**CITY OF TEMPE  
DEVELOPMENT REVIEW COMMISSION**

**Meeting Date: 02/11/2014  
Agenda Item: 5**

**ACTION:** Request for a Development Plan Review consisting of a new drive thru restaurant building for CULVERS RESTAURANT located at 630 East Southern Avenue. The applicant is Evergreen Devco.

**DEVELOPMENT PROJECT FILE**  
for  
**CULVER'S RESTAURANT**

SHEET TITLE:  
**EXTERIOR ELEVATIONS**

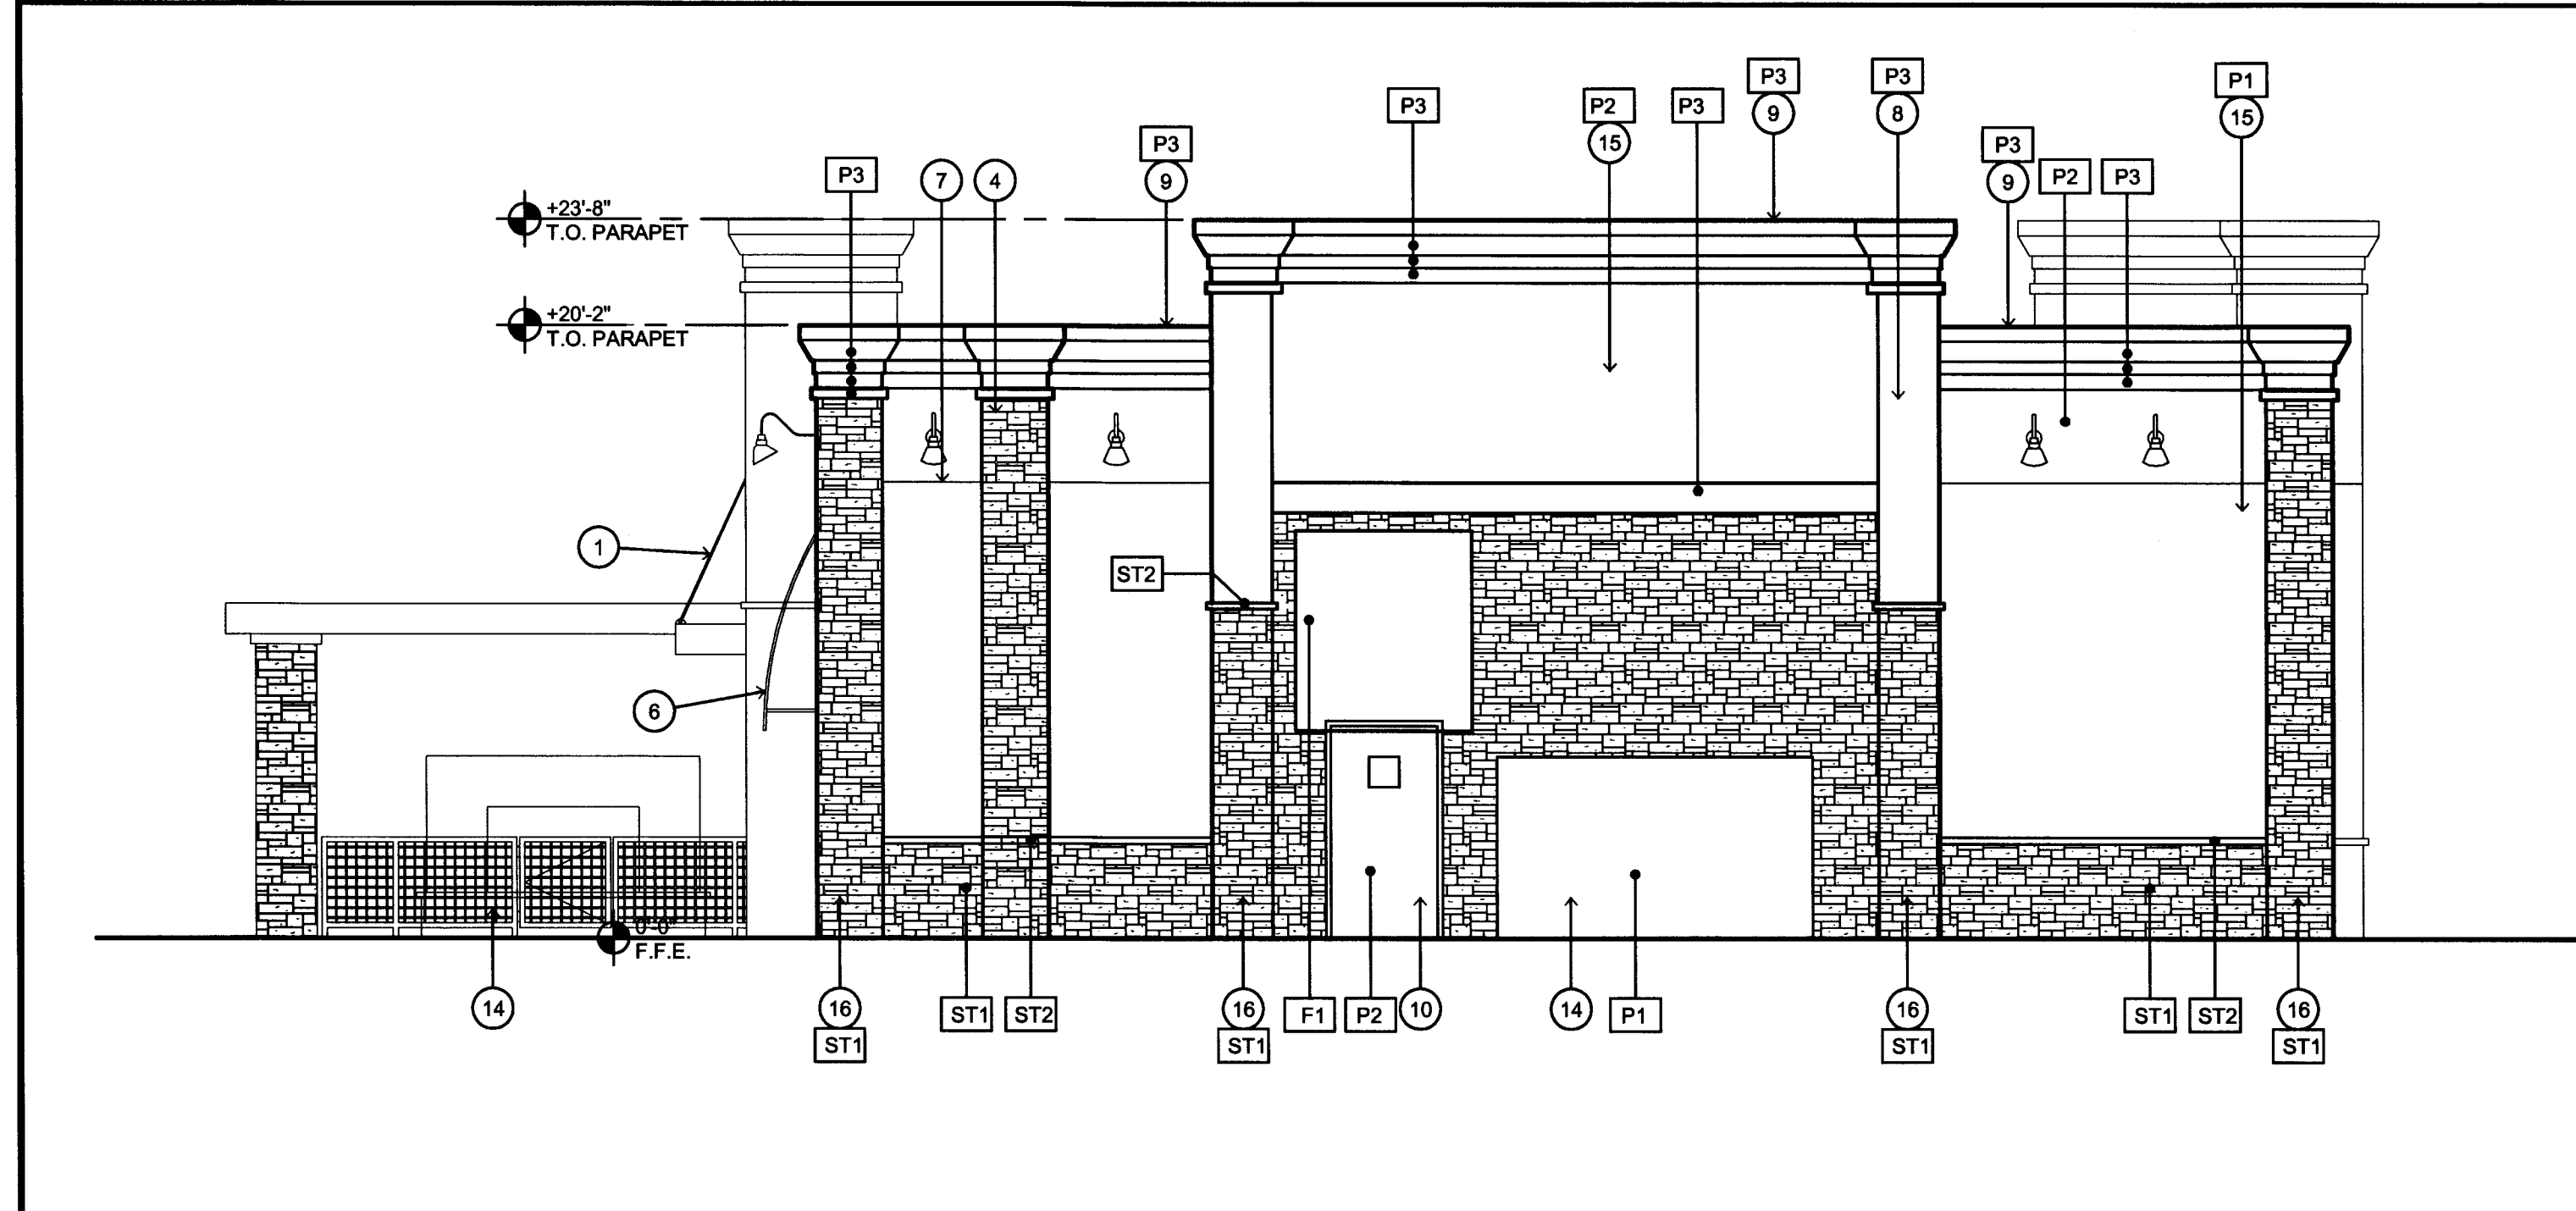
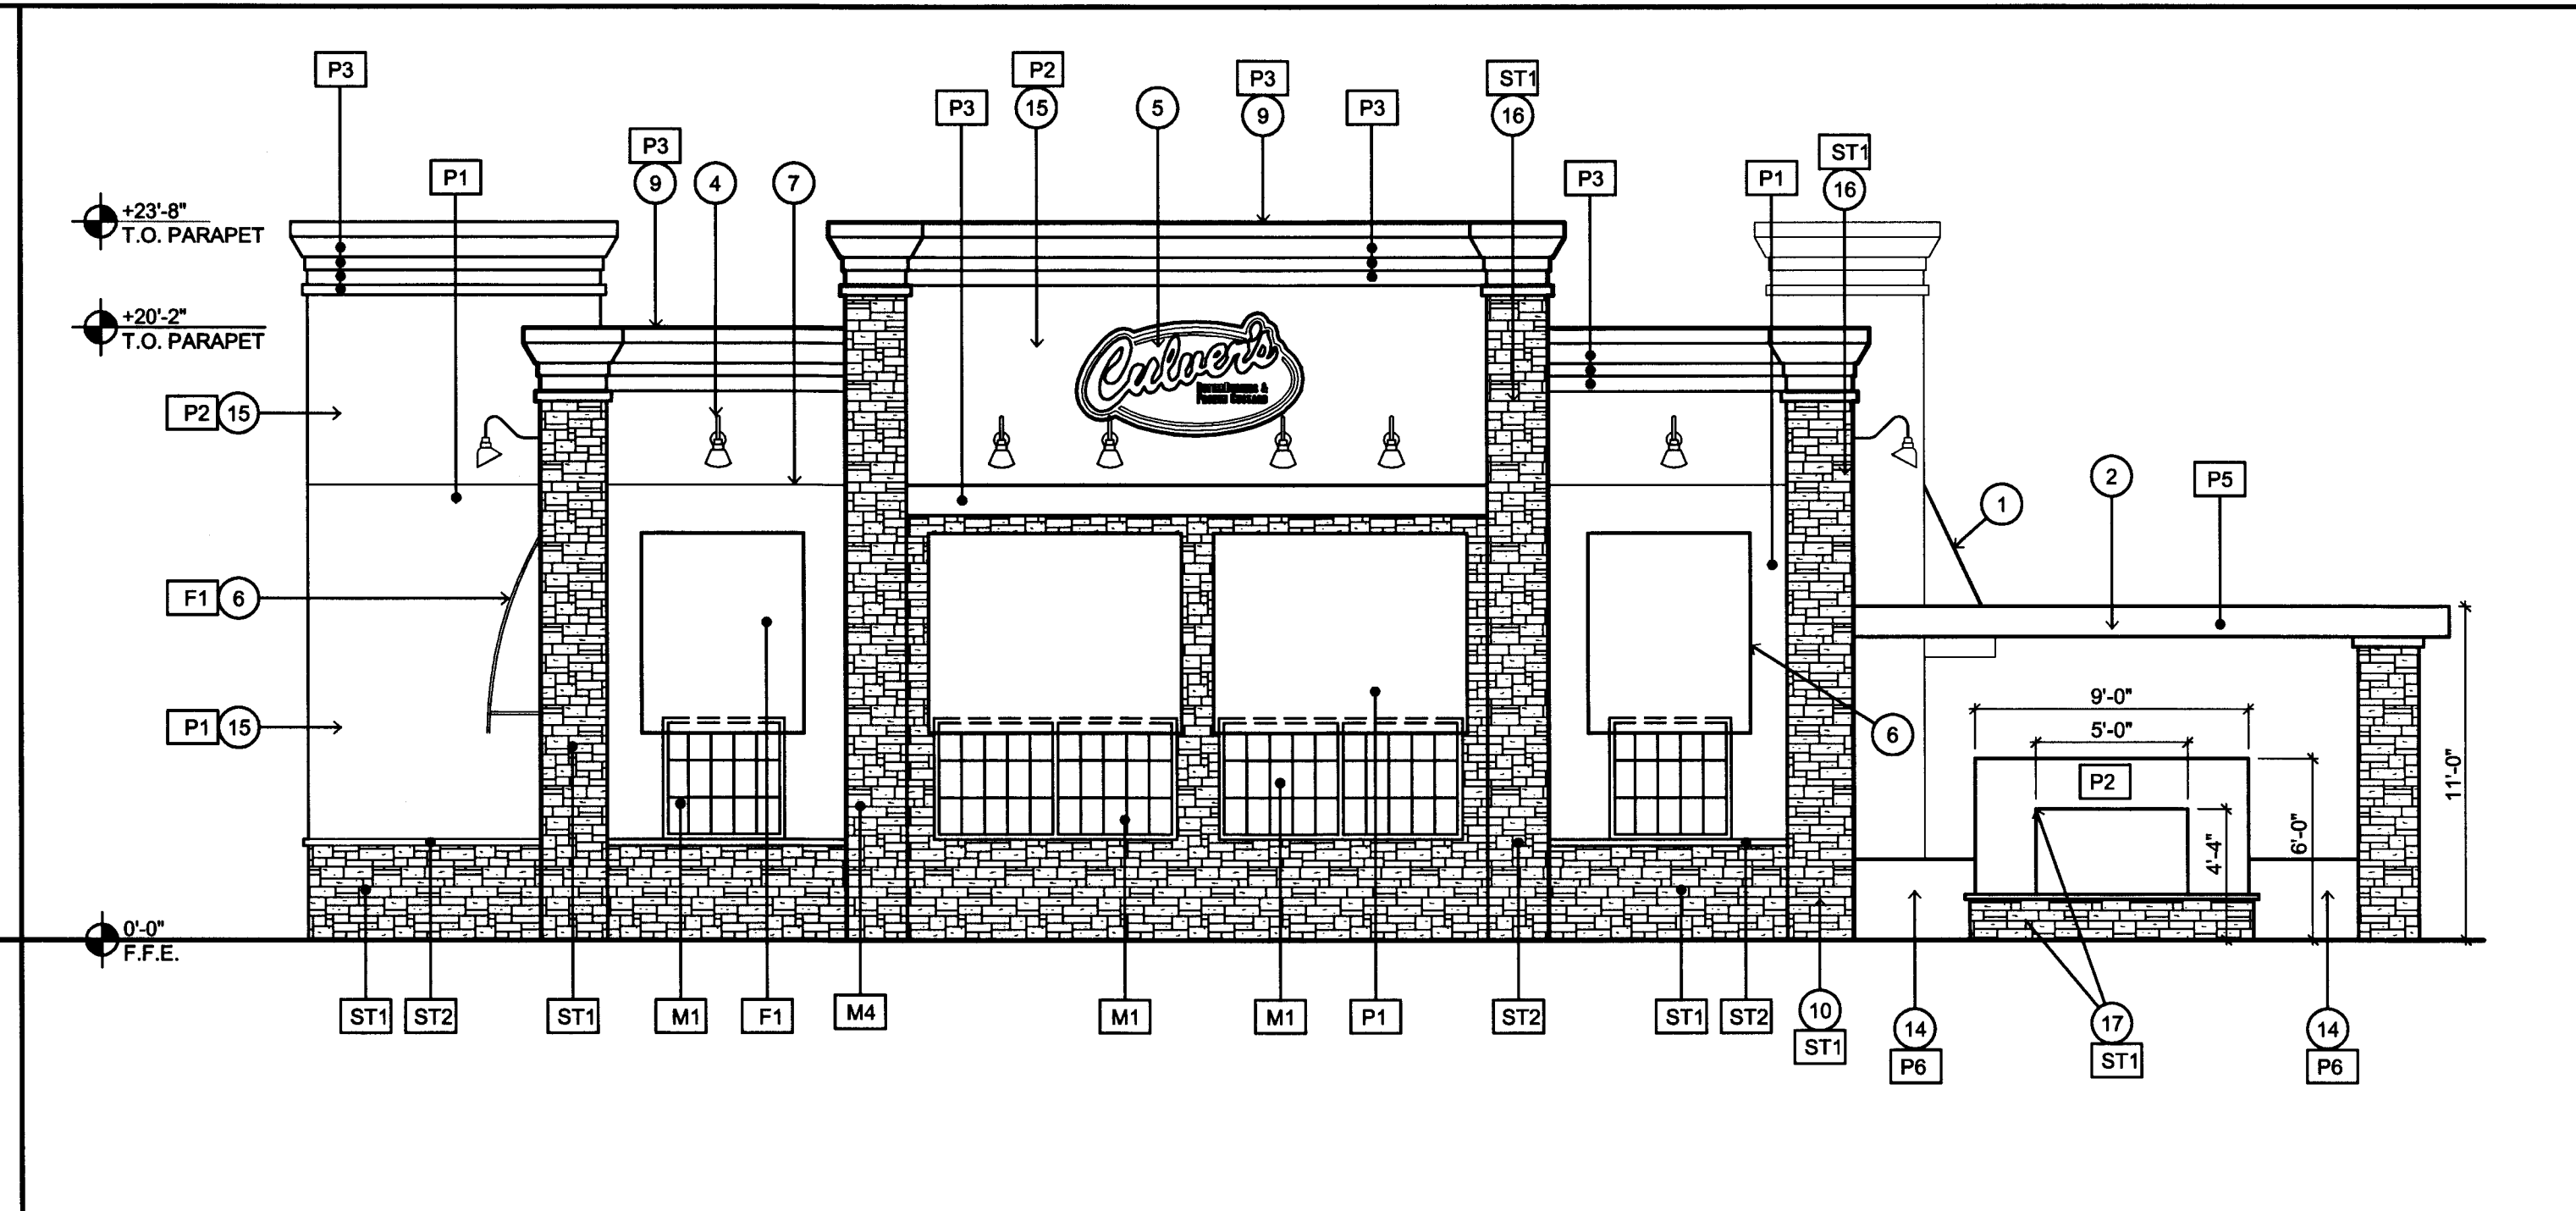
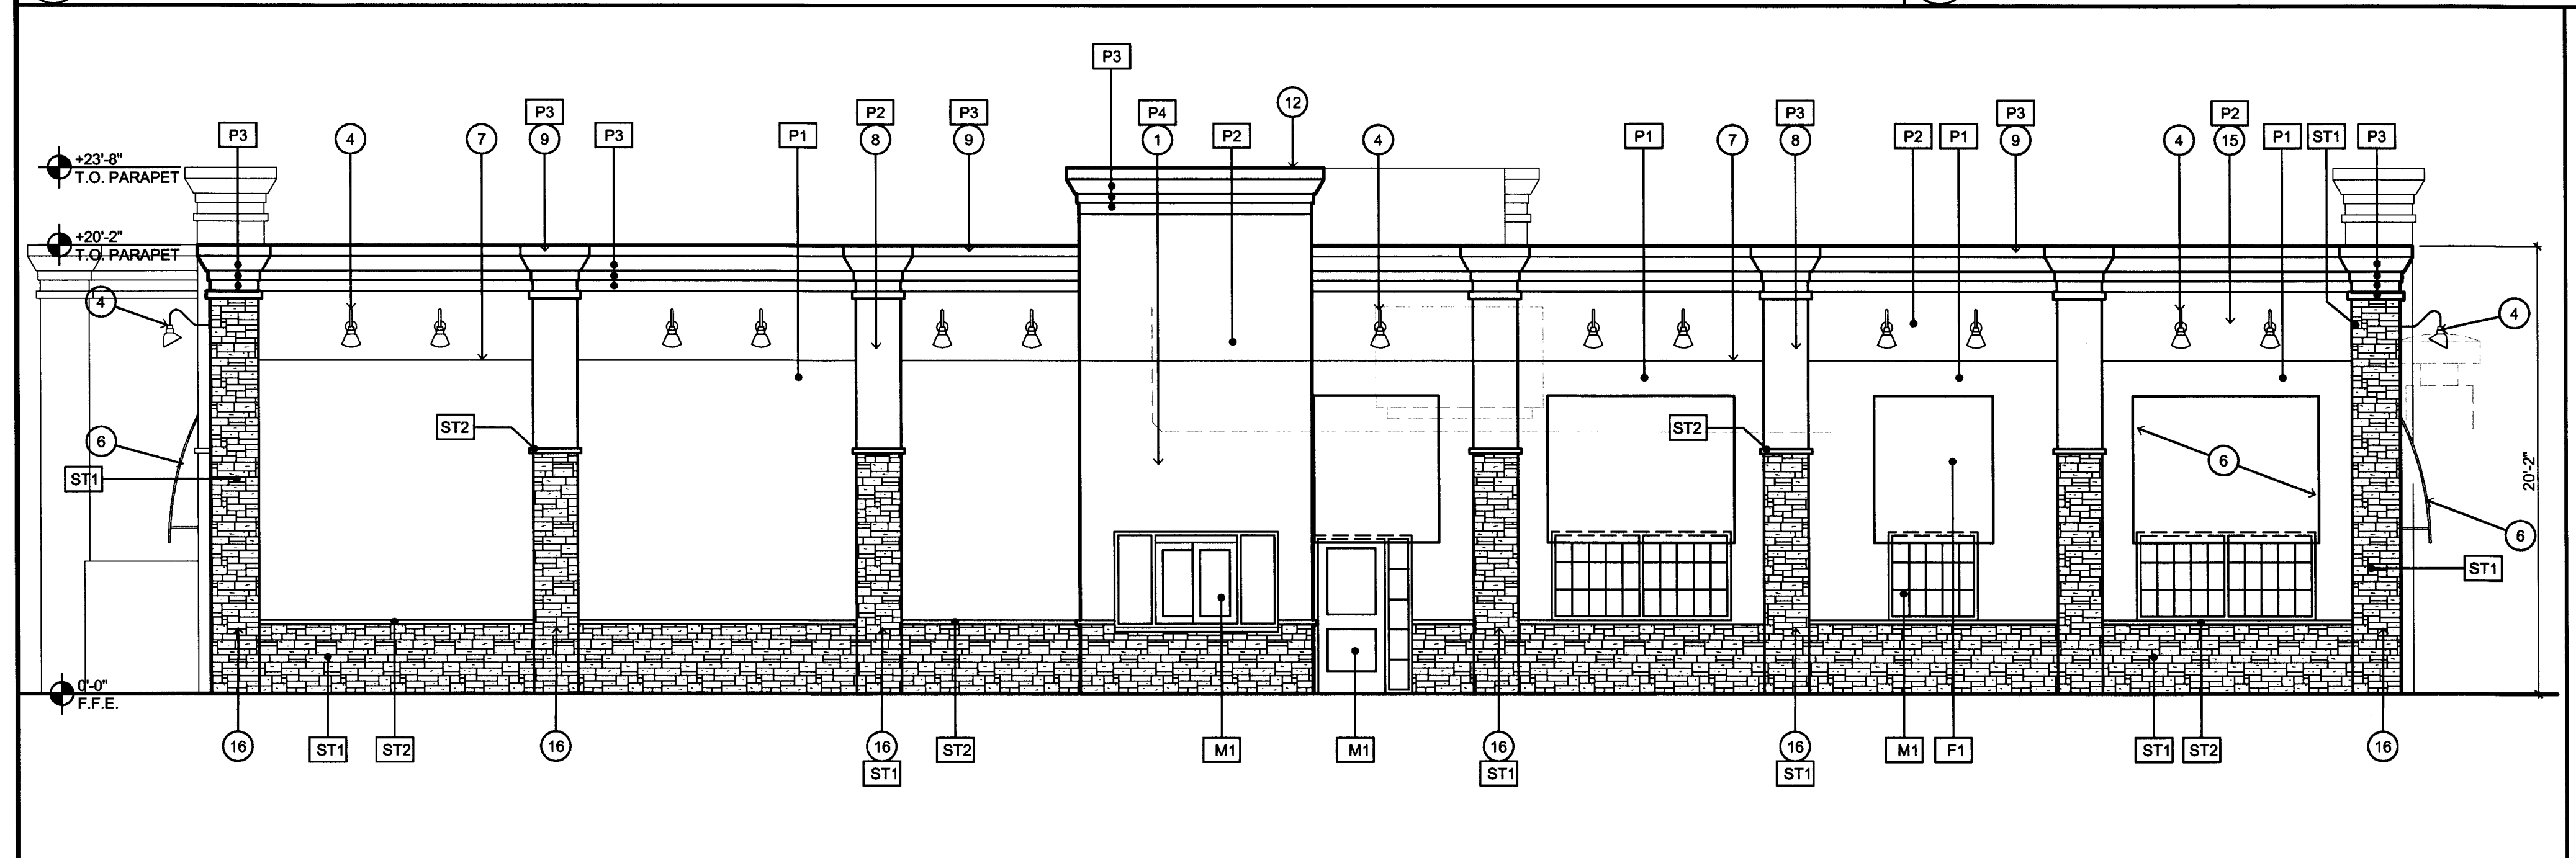
3. *Materials are quality, providing detail appropriate with their location and function while complementing the surroundings;* staff modification to a masonry brick material will complement to the surrounding aesthetic.

4. Provide materials and colors are per the following:
  - Modify stone to a brick veneer- color to be reviewed and approved in planning plan check process.
  - Paint Colors –
  - Body color- DEC739, Golden Gate (Beige)
  - 2<sup>nd</sup> Body Color- DEC 6110- Warm Hearth (Tan)
  - Modify Cornice Trim Color and Steel Awning- to a lighter contrast brown shade color to be reviewed and approved in planning plan check process.
  - Provide main colors and materials with a light reflectance value of 75 percent or less.
5. For roof access provide internal ladder access fully screened at parapet.
- 6.. Minimize visible, external features, such as overflows, and where needed design these to enhance the architecture of the building.
